ADDENDUM NO. 1

Owner: City of Pasco
525 North 3rd Ave
Pasco, Wa 99301

Date: September 21, 2022
Project: Pasco Fire Station 85

FOUNDATION PLAN

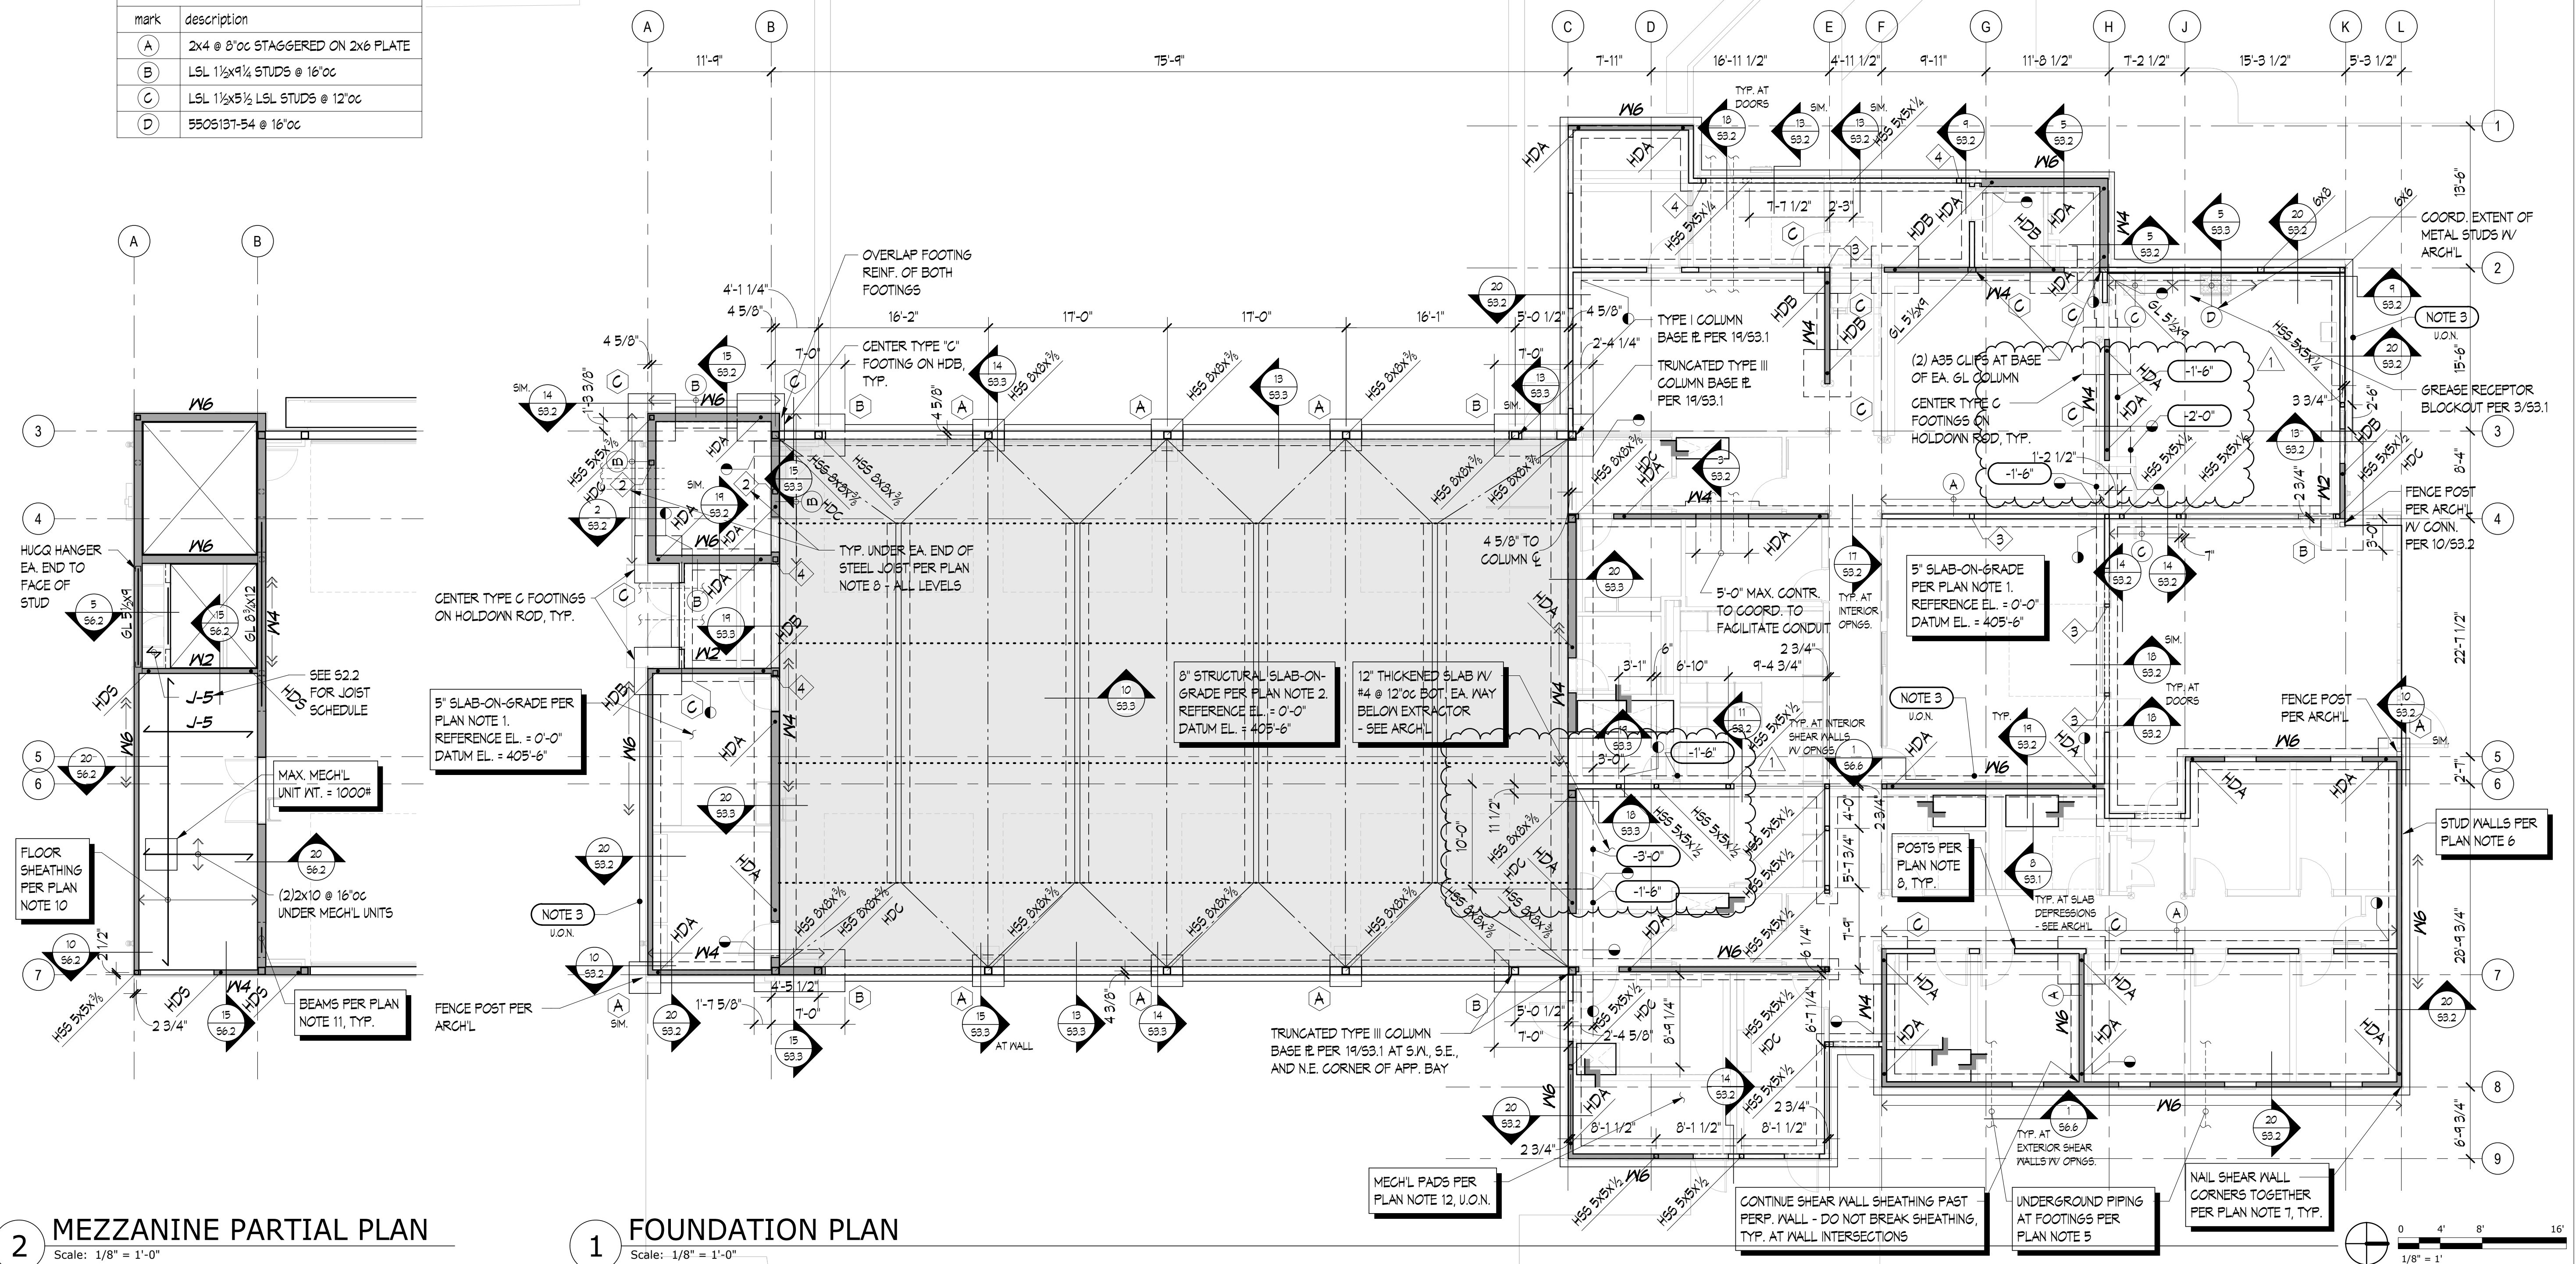
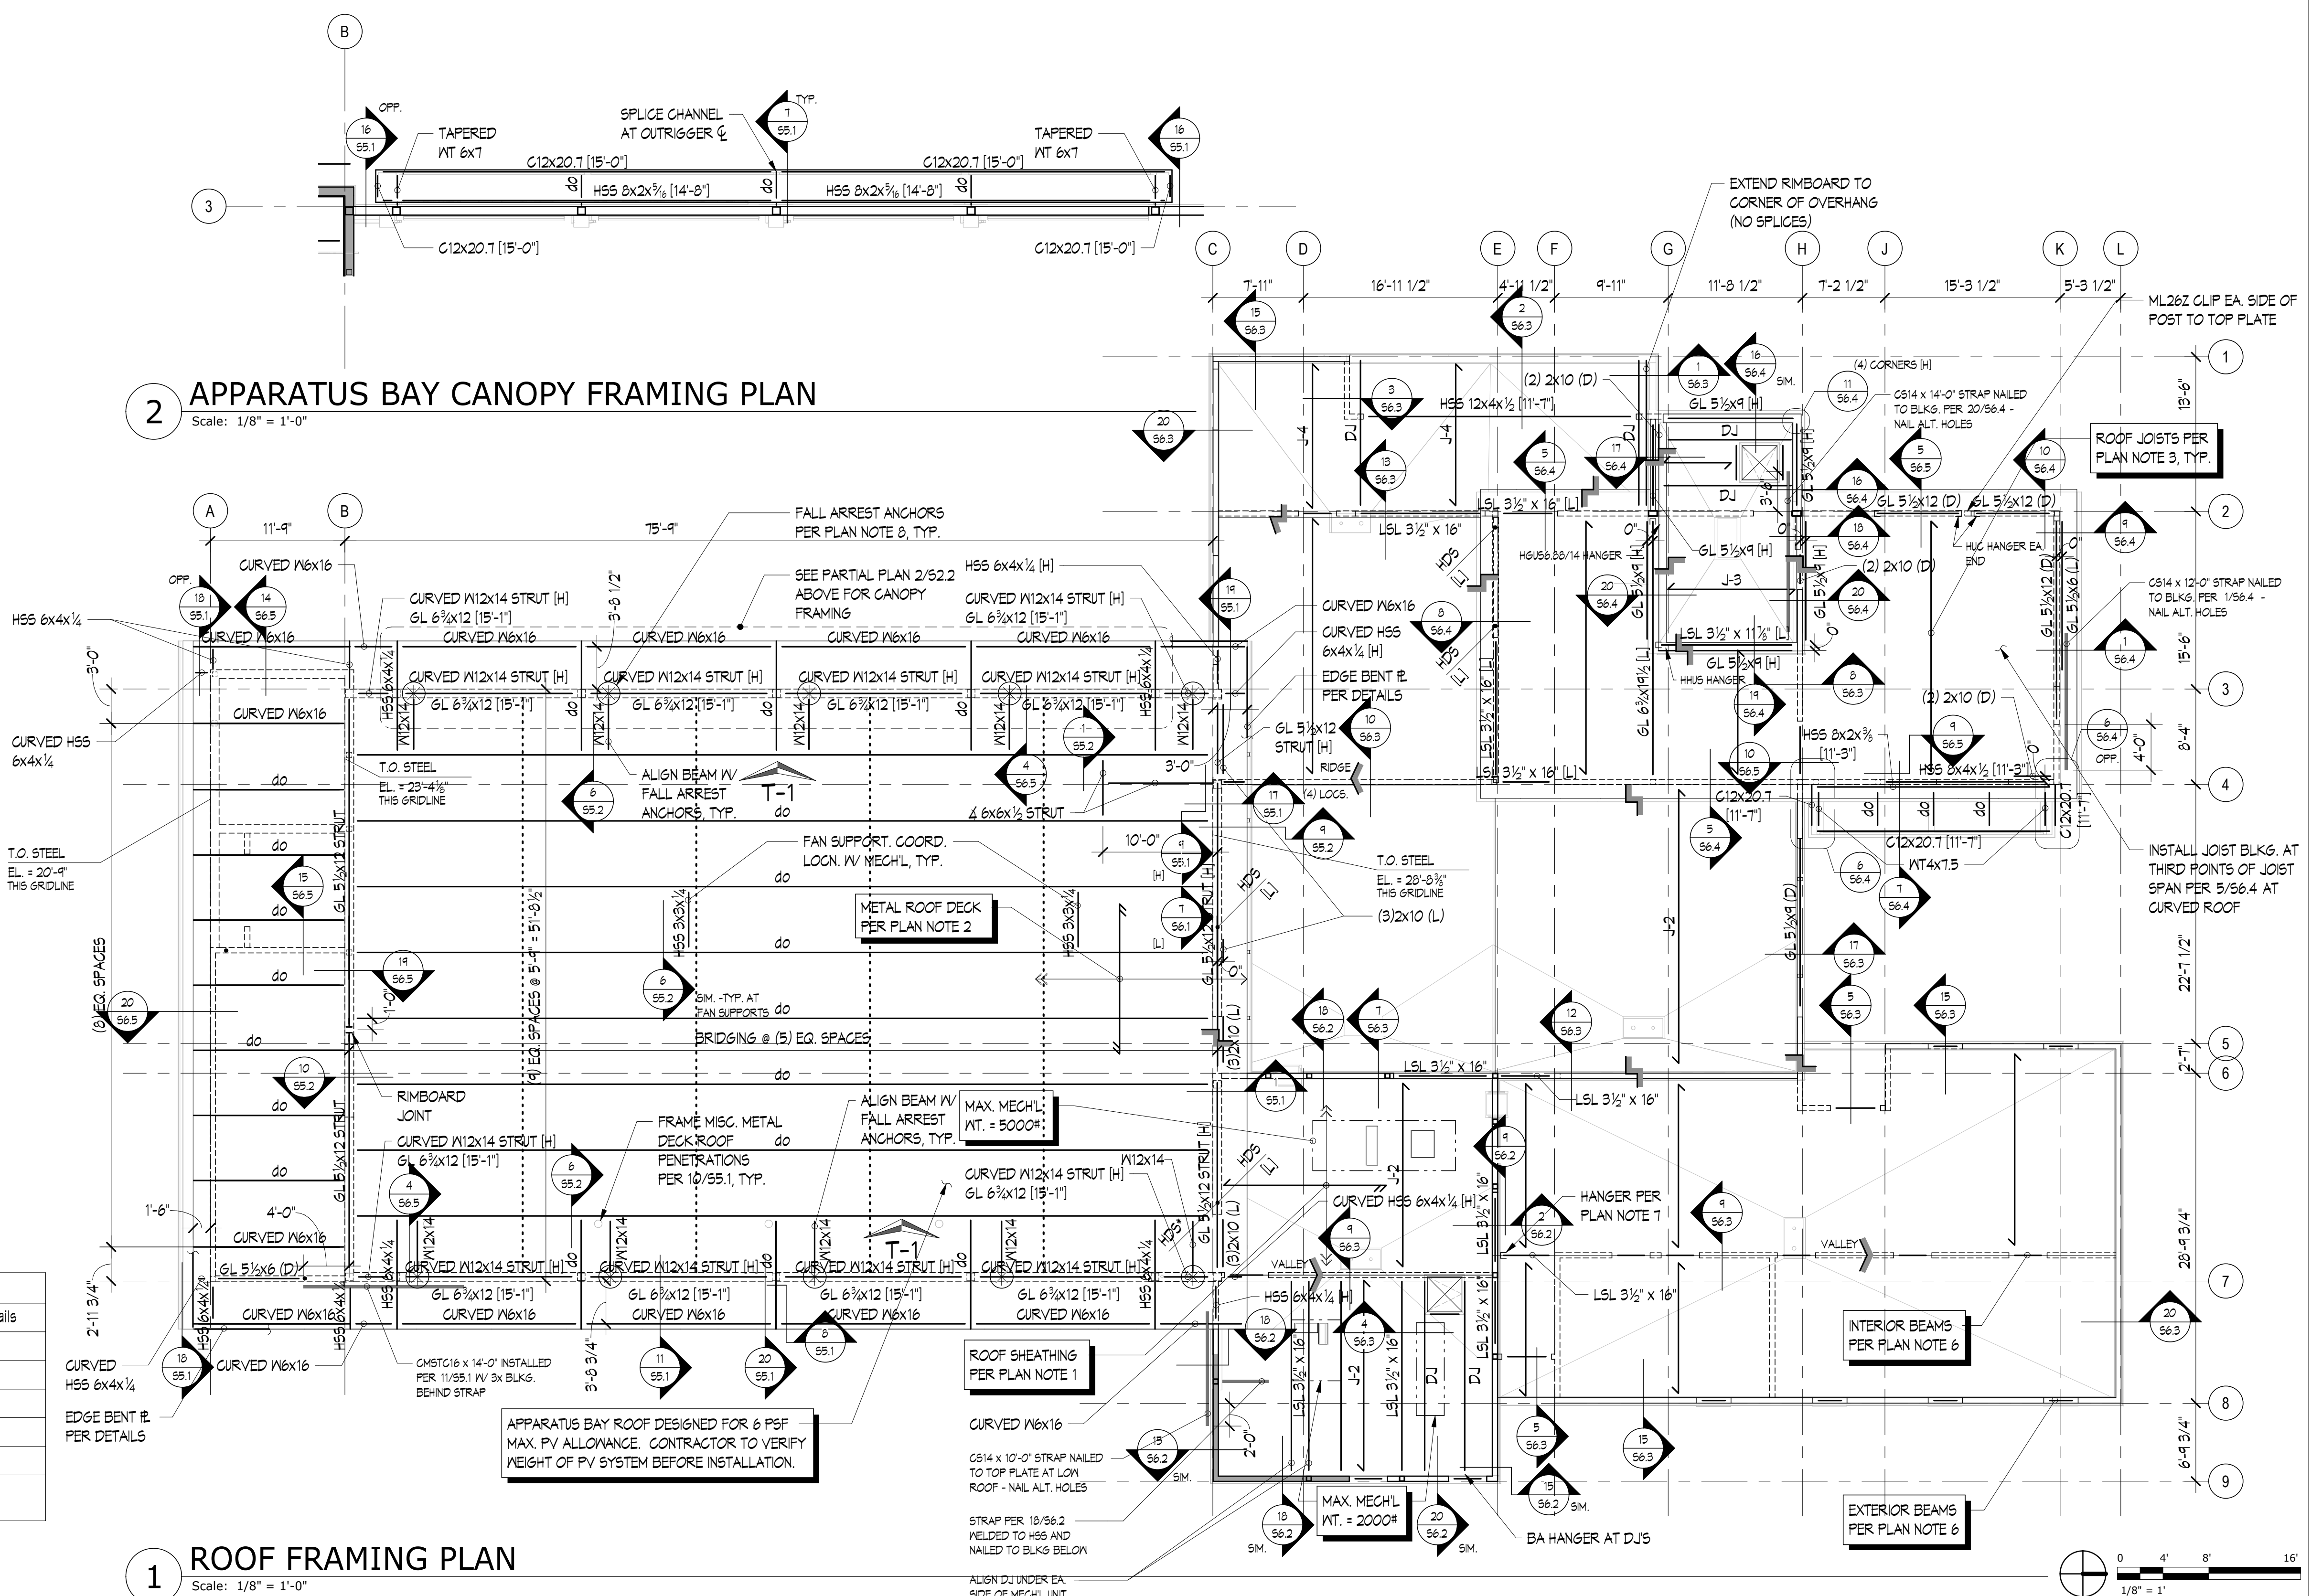
1. Refer to attached Structural Drawing set all sheets replaced with removed "Not for Construction" note.
2. S2.1 FOUNDATION PLAN
 - a. Adjusted footing elevation near grids 3-H.
 - b. Adjusted footing elevations near grids 6-C.
3. S6.1 TYPICAL WOOD FRAMING DETAILS.
 - a. Revised detail 15/S6.1.
4. S6.4 WOOD ROOF FRAMING DETAILS.
 - a. Revised detail 20/S6.4.
